## FOOTHILLS WATER NETWORK

**COMMENTS ON DRAFT LICENSE APPLICATIONS FOR  
DRUM-SPAULDING PROJECT # 2310 AND  
YUBA-BEAR PROJECT # 2266**

February 1, 2011

**Figure 12 - Spaulding Reservoir 15-minute Flows 1999**

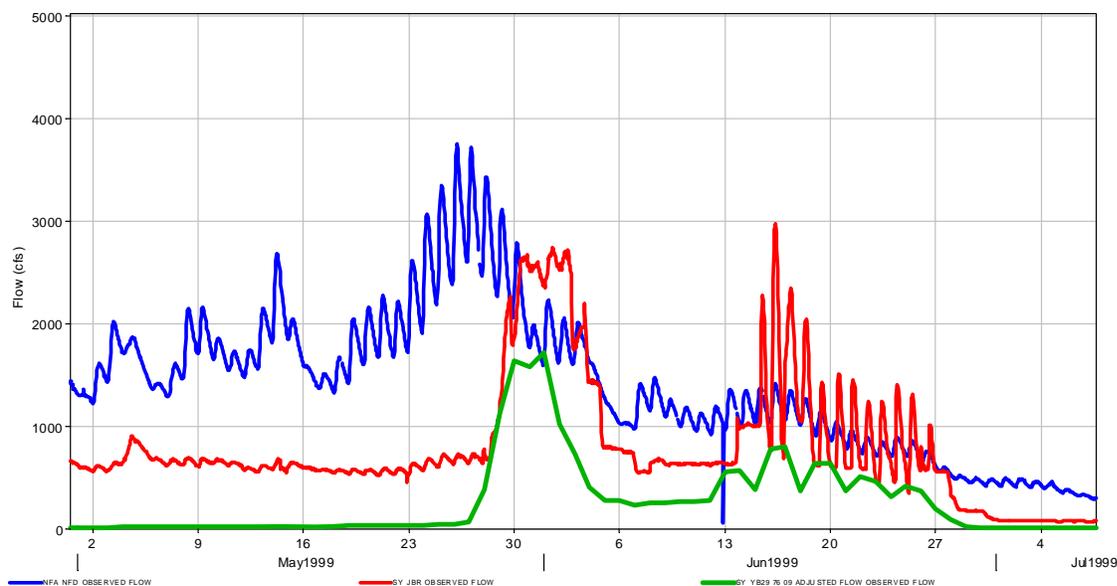
The PG&E FLA should include three infrastructure improvements and complete deferred maintenance to Spaulding Reservoir and Dam, which will enhance the South Yuba River. These are 1) Improve automatic gate control at Spaulding Dam 2) increase capacity to release higher flows when water is not on the gates, and 3) Repair leaks on the face of or through the rock at Spaulding Saddle Dams to cool water temperatures in Jordan Creek and in turn, the South Yuba River.

First, the FLA should include an infrastructure improvement to improve the automatic gate controllers at Spaulding Reservoir. Currently the automatic gates appear to release spiky 15 minute spills that can wash away FYLF habitat, egg masses, macroinvertebrates, and trout roe. We surmise that the automatic gates could be over-controlling, which may be causing the spill pattern illustrated in Figure 11. The 15-min. hydrograph shows these spiky fluctuations but the average daily hydrograph does not.

Second, the PG&E FLA should include the ability to release more than 16 cfs to the South Yuba when water is not on the gates for purposes such as pre-release prior to spill and to reconstruct the descending limb of the natural hydrograph.

- Repair the lower level outlet by removing upstream debris; installing Grizzly; repairing pipe as necessary; installing cone valve at downstream end to accommodate hundreds of cfs.
- Modification of power intakes and outlet below Spaulding #2 Power House to accommodate hundreds of cfs.
- Deepen the radial gates to allow for pre-release into the South Yuba River.

**Figure 13 - Temperatures of the South Yuba River Above Jordan Creek 2009**

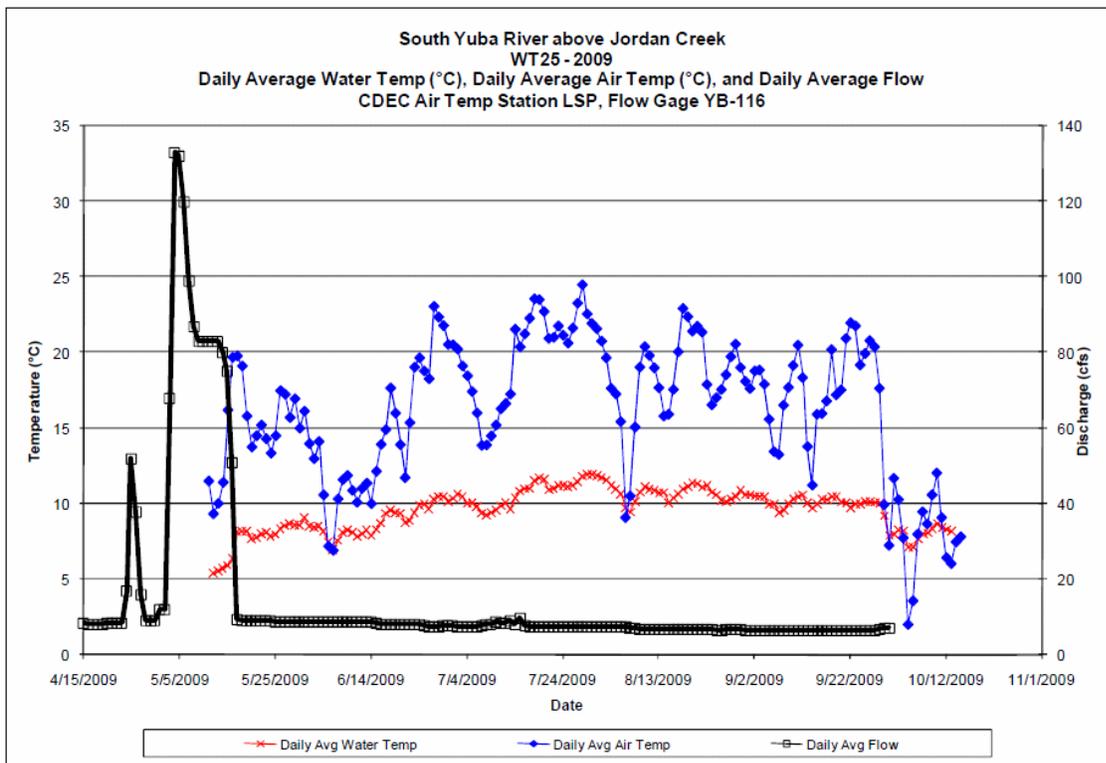
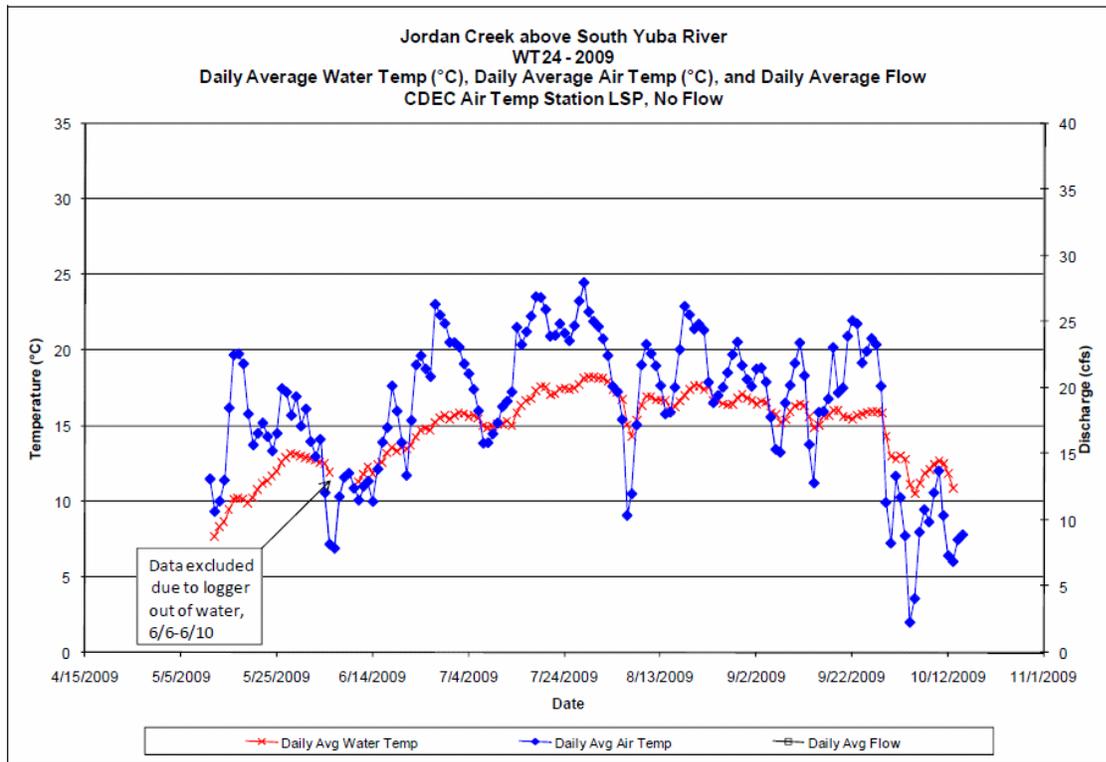
Third, the PG&E FLA should also include a proposal to repair the leaks on the face or through the rock of Spaulding Saddles Dam. As seen in the graphs below, a comparison of temperatures in Jordan Creek and South Yuba River show that Jordan Creek is quite a bit warmer. We hypothesize that the leak from Spaulding Dam's face into the Jordan Creek channel creates this temperature difference. The result is avoidable warming of the South Yuba River. By eliminating this temperature pollution plume, the project can cool water temperatures and enhance rainbow trout habitat in the South Yuba River downstream of Spaulding Reservoir.

**Figure 15 Synthesized unimpaired and observed regulated flow in the Bear River at Highway 20.<sup>50</sup>**

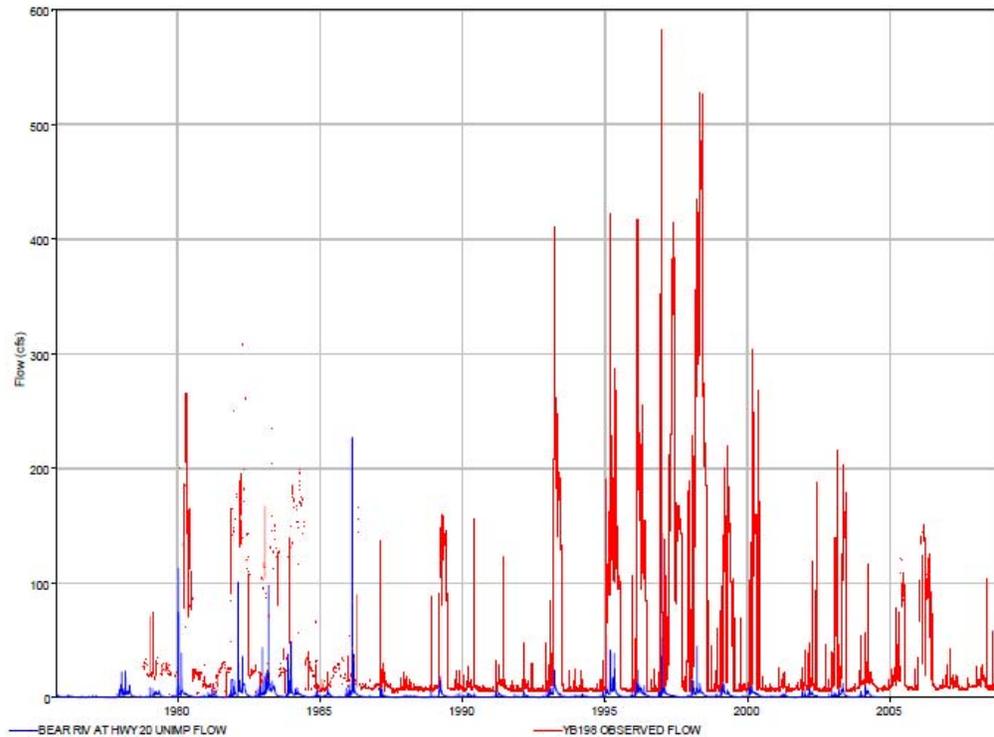
As shown in Figure 1, the project regularly increases flows from 100 cfs or less up to 300 - 400 cfs, and occasionally greater than 500cfs down the valley with little to no up- or down-ramping (see graph from April and May 2010). The Foothills Water Network has commented on this issue in our Comments on the YBDS PAD<sup>51</sup>; Comments on the YBDS Study Report<sup>52</sup>; and in Comments on Revised Study Plan:

**Figure 16 Flows on Bear River at Hwy 20 Bridge, 1997-1998**

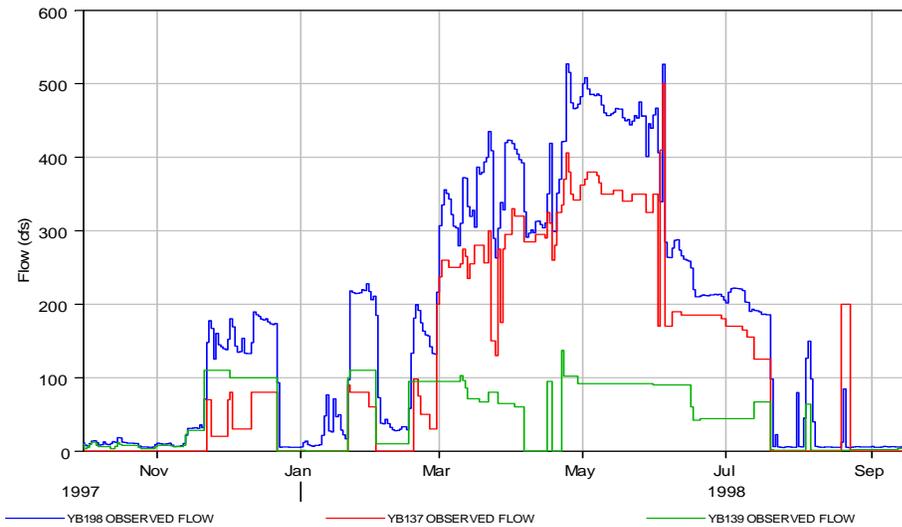
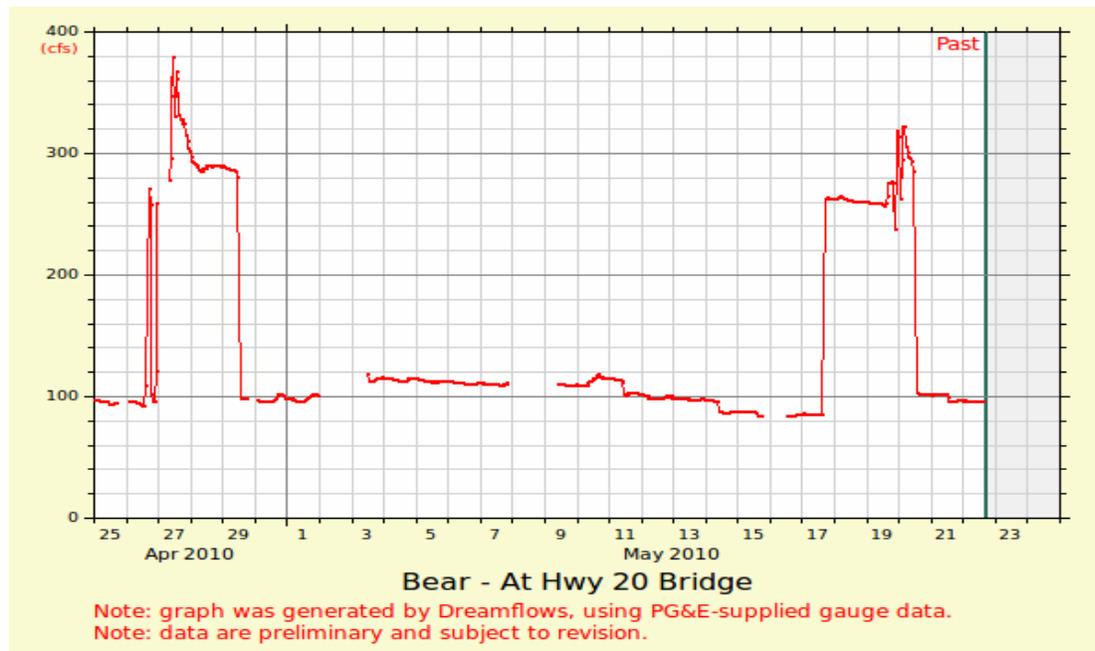
The graphs above and below illustrate that the project significantly augments the natural flow in the Bear Valley. At times, PG&E uses the Bear River in Bear Valley as a conveyance reach to move water from the Yuba watershed through the YBDS hydropower system and not lose it down the South Yuba River, (See section 5.5 of these comments).<sup>53</sup> Again, the following graph below demonstrates extreme flows with inappropriately fast ramping rates.

The PG&E DLA includes a proposed ramping rate measure of 0.4 ft/hr maximum rate of stage change for the Bear Valley Above Drum Afterbay. The Network appreciates PG&E’s efforts to reduce project effects of rapid flow fluctuations in the Bear Valley. However, our main objective is to avoid use of this stream reach as conveyance and thus avoid the ongoing negative geomorphic impacts to Bear Valley. The use of this reach as conveyance limits the restoration opportunities in the Bear Valley.
